PRELIMINARY

SP245

v1_Preliminary Plan Drawings.pdf Markup Summary

remove the

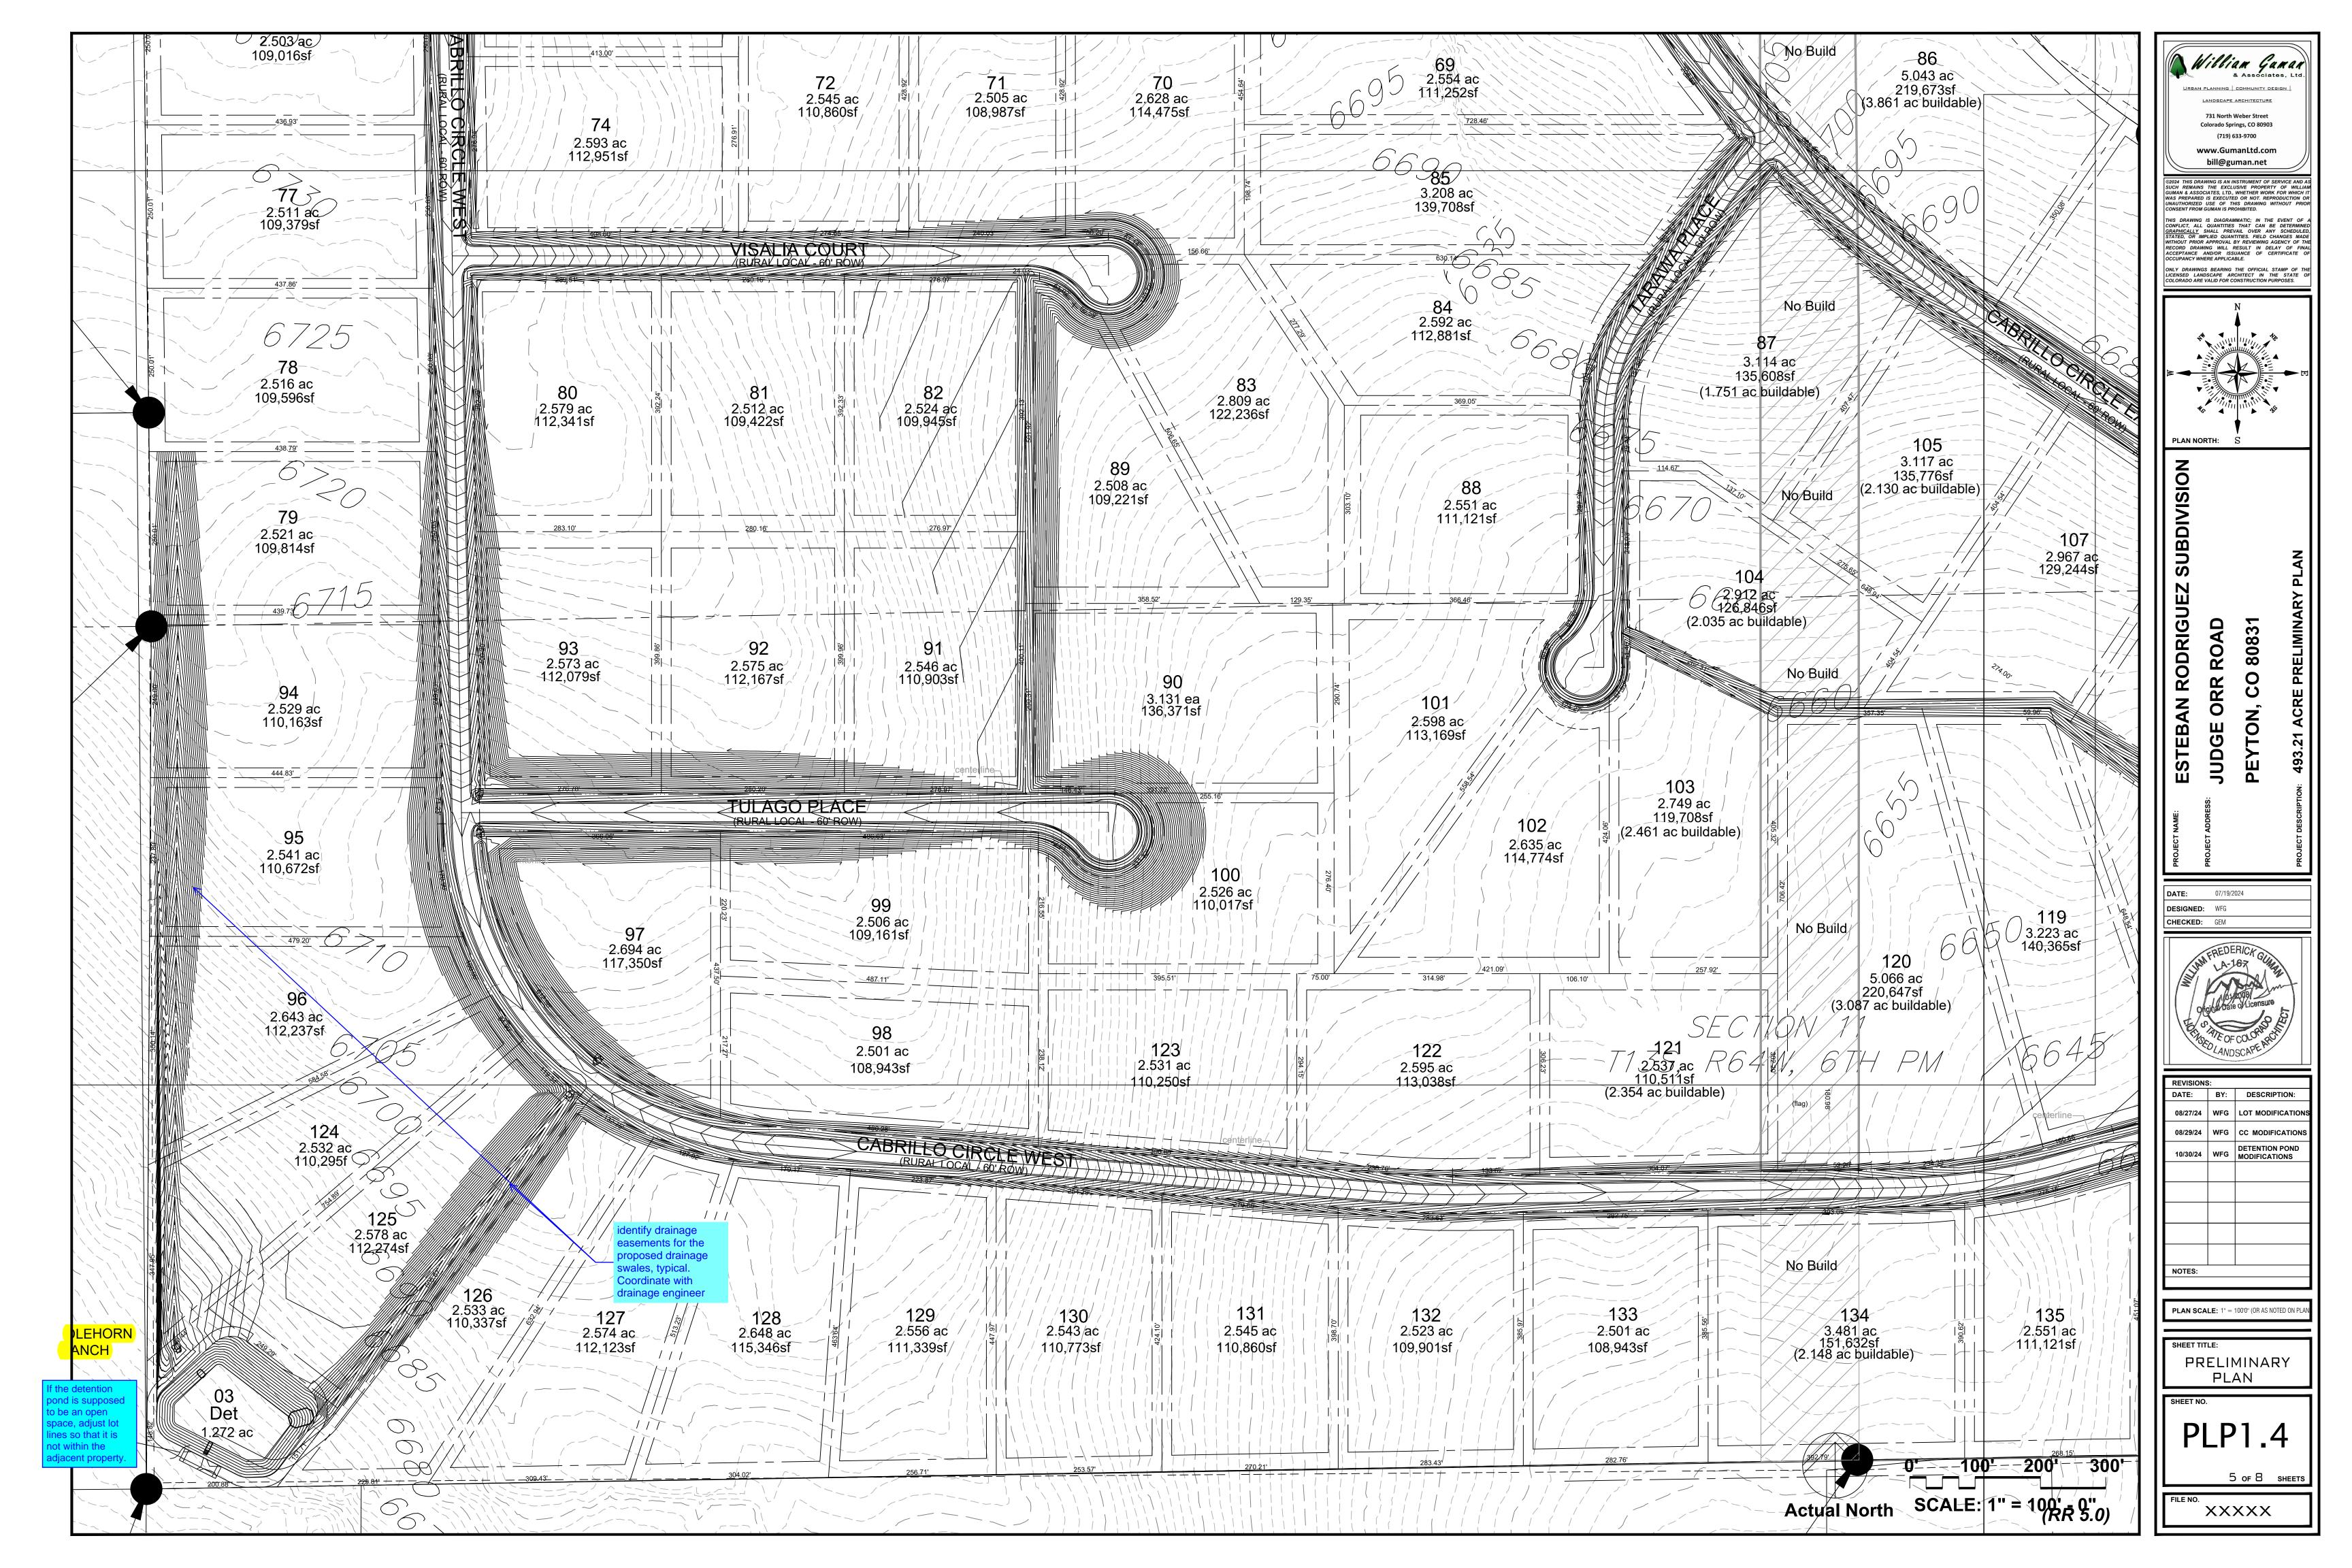
one note

recommend i

a condition of

expiration

Status: Color: ■ Layer: Space: Include standard soils and geo note as seen

Status: Color: E Layer: Space: make the language specific to the well and septic

Status: Color: Layer: Space: please update this to preliminary plan

Status: Color: ■ Layer: Space: make sure this is one note

Status: Color: Layer: Space: please make it more obvious where these areas are on the plan other than no build areas, the no build areas represent multiple items and it should be better specified

Status: Color: Layer: Space: lot number has increased from sketch plan - this

cannot be increased, change to 142

Status: Color: Layer: Space: recommend remove this note , this will be a condition of approval and it will be changed to 2 yr

Status: Color: ■ Layer: Space: recommend removal covered in note 25

show 2% per EPC standard detail.

Status: Color: Layer: Space: remove this sketch plan note

Status: Color: Layer: Space: Please remove or revise this note #5. The access points are not conceptual at the prelim plan stage.

Please show existing and future roadway cross sections separately for clarity.

Please add typical slopes to all sections.

6 of 8 SHEET

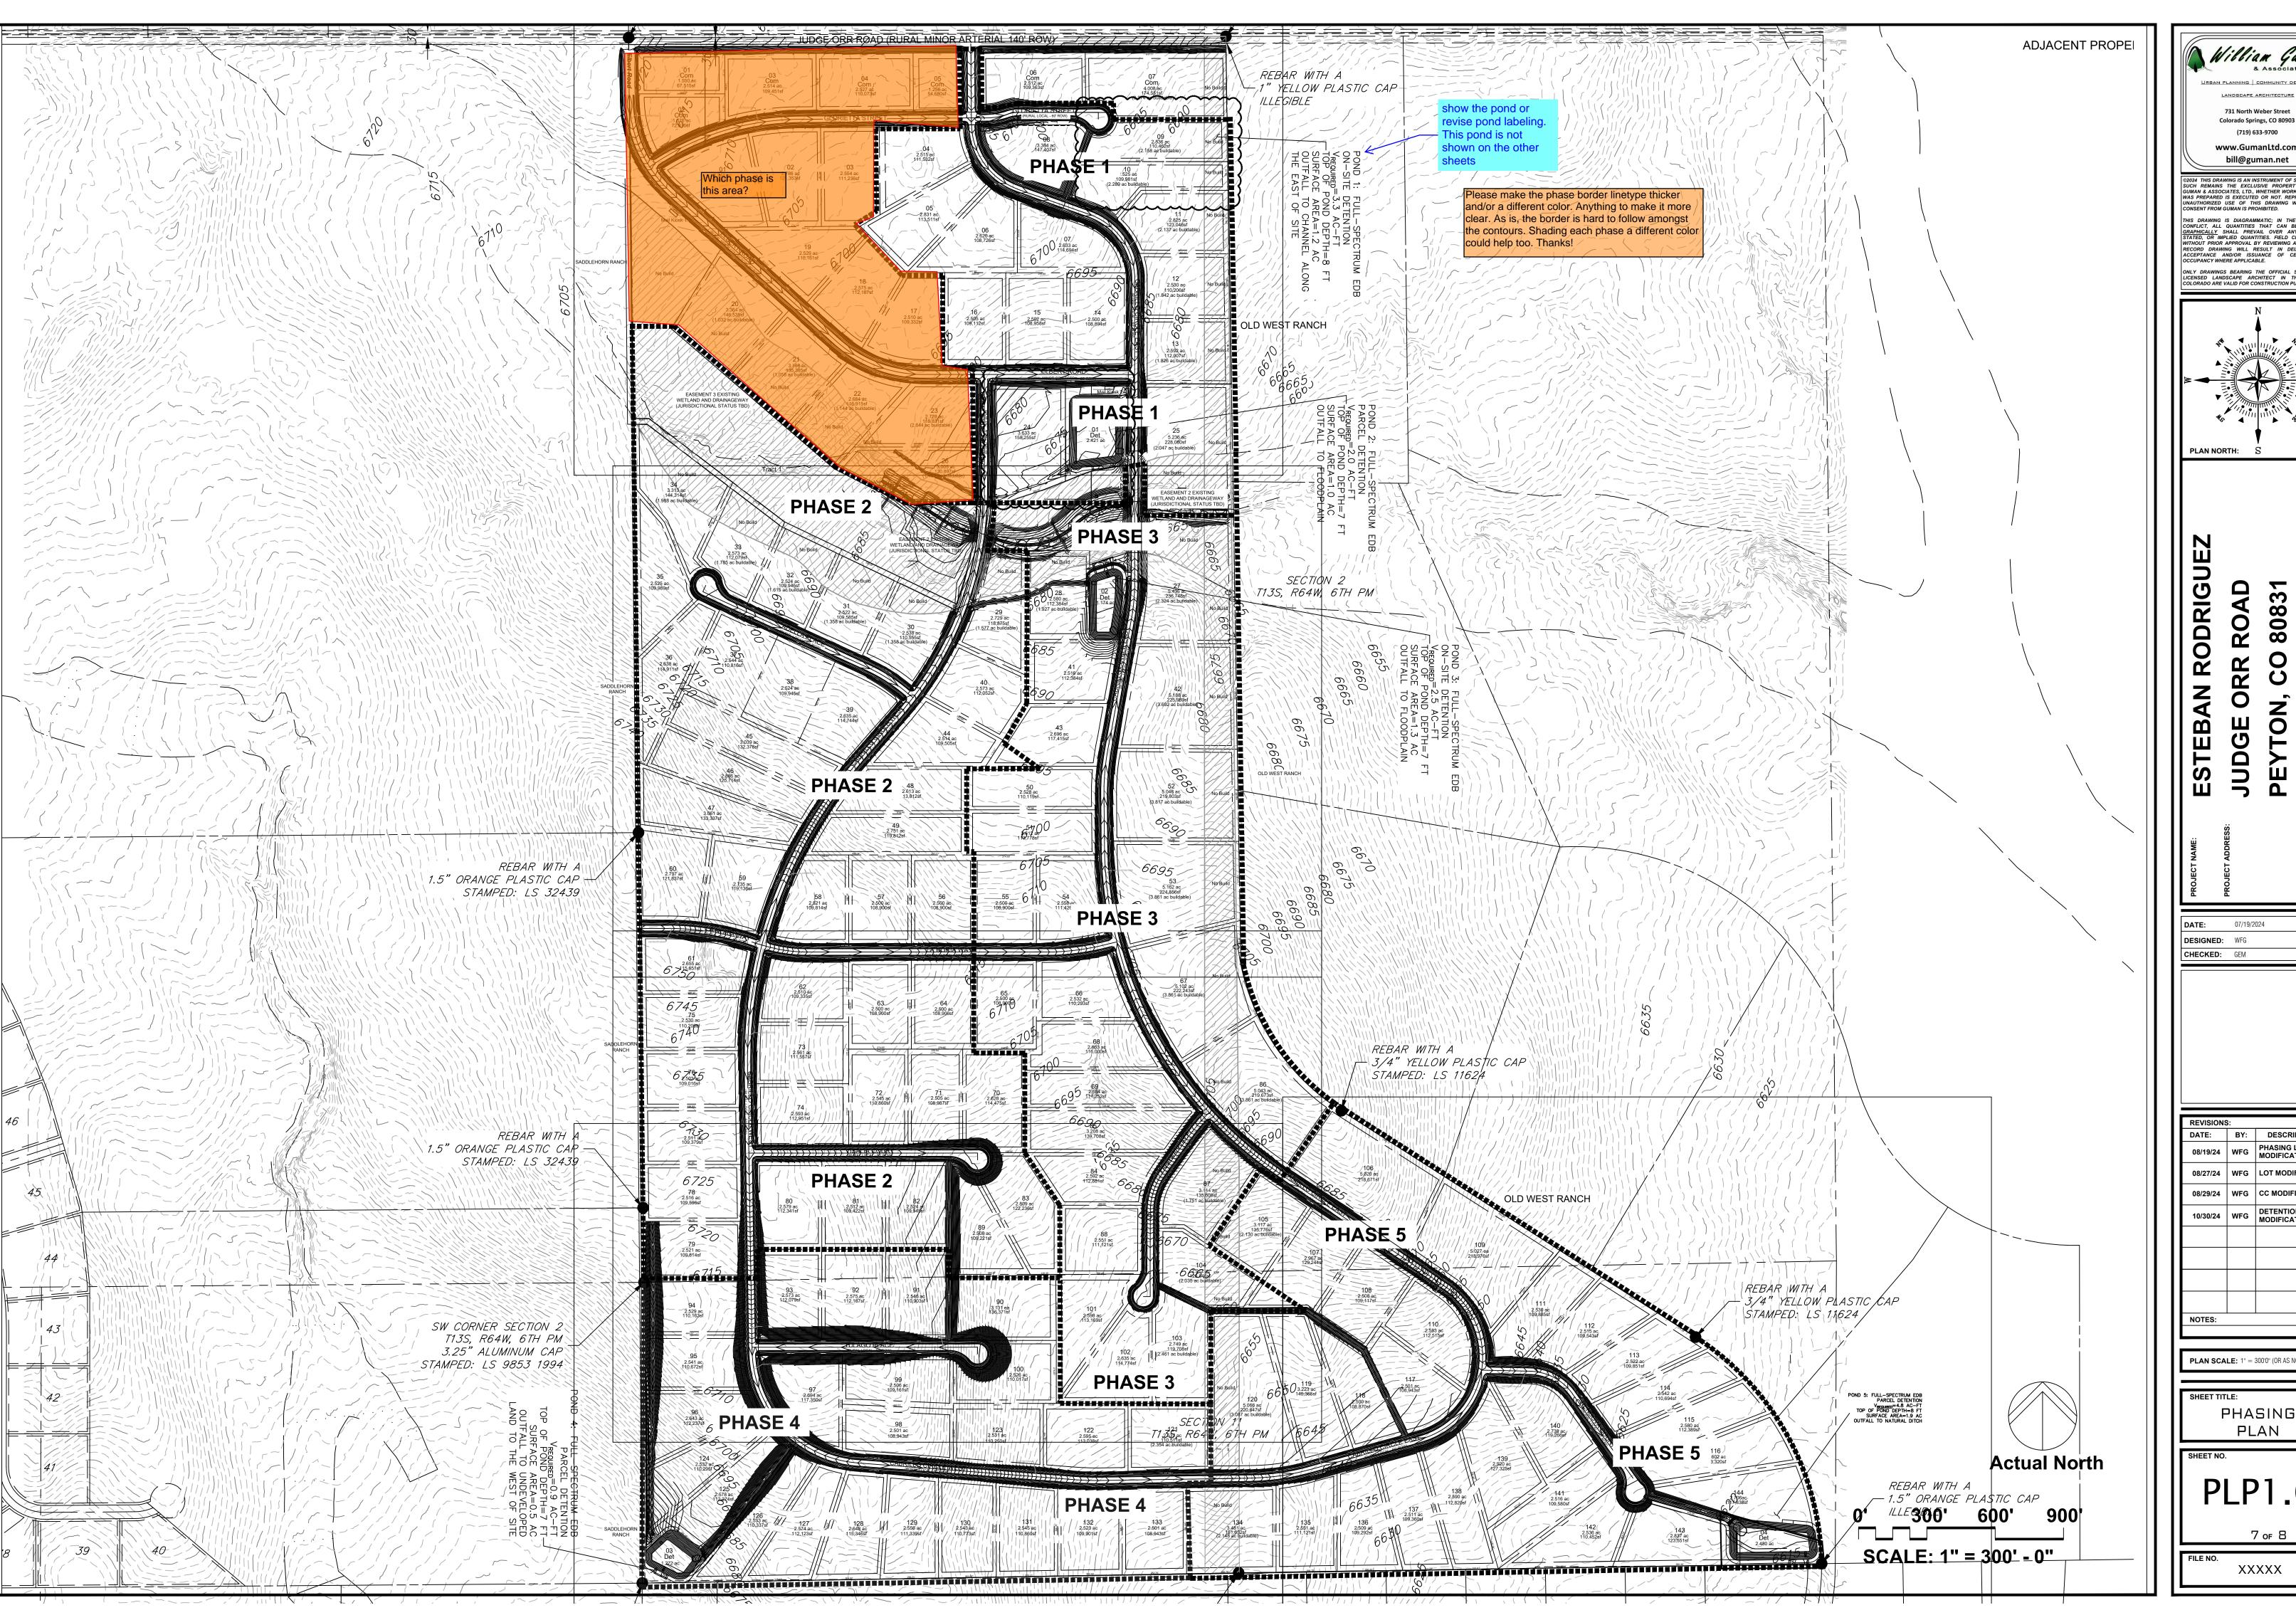
Status: Color: ■ Layer: Space: where is the 7 acre park as depicted within the

Sketch plan? Parcel J

Status: Color: Layer: Space: please indicate the proposed owner and maintenance entity of the detention pond tracts.

Additionally please indicate who will maintain the channel (Geick Trib.) that traverses the development; HOA or Metro district?

Status: Color: Layer: Space: 1-4

Status: Color: Layer: Space: If the detention pond is supposed to be an open space, adjust lot lines so that it is not within the
